**MINOR VARIANCE APPLICATION
COMMENTS TO THE COMMITTEE OF ADJUSTMENT
PANEL 2**

Site Address: 1919, 1967 Riverside Drive
Legal Description: Part of Lots 15 and 16, Concession Junction Gore and Part of Road Allowance between Lots 15 and 16 Concession Junction Gore (Closed by By-Law 174-88, Inst. N451929) Geographic Township of Gloucester.
File No.: D08-02-23/A-00131
Report Date: July 13, 2023
Hearing Date: July 18, 2023
Planner: Justin Grift
Official Plan Designation: Outer Urban, Neighbourhood, Evolving Overlay
Zoning: I2 F(1.0)

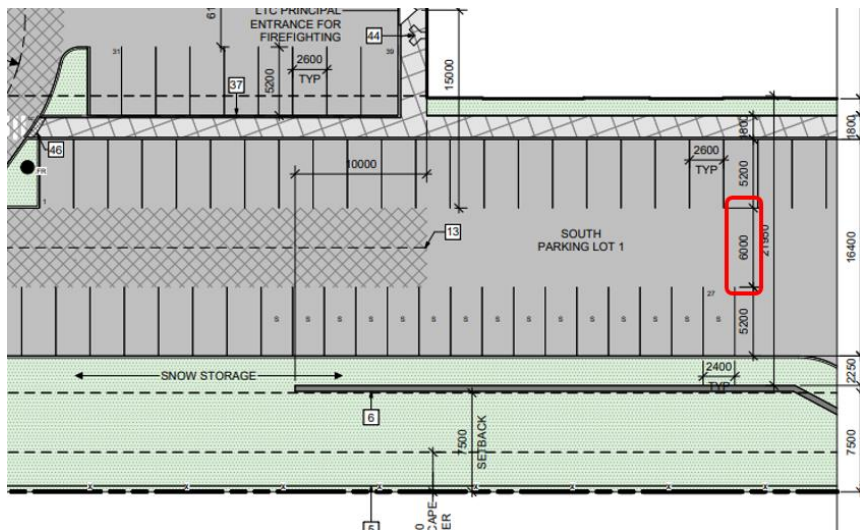
As seen in the plans provided, the applicant is proposing compact parking spaces in several of the new parking lots on the site. However, in the East Parking Lot 2, all 65 of the parking spaces are proposed to be compact car spaces and reduced from the standard parking dimensions in the Zoning By-law. The applicant is seeking relief to have 100% of the parking lot as 'compact car' spaces.

Staff does not have concerns with requested variances e and f. Considering there are a total of 311 new parking spaces being provided in the development and less than 120 will be 'compact car' spaces, Staff is of the opinion the intent of the Zoning By-law is being met and there are still adequate amounts of standard sized parking spaces available on site. Further, the applicant has confirmed that East Parking Lot 2 will be reserved entirely for on-site staff parking and will not be available for visitors. Therefore, the East Parking Lot 2 will have a management component to mitigate any issues with standard-sized vehicles attempting to park on this lot.
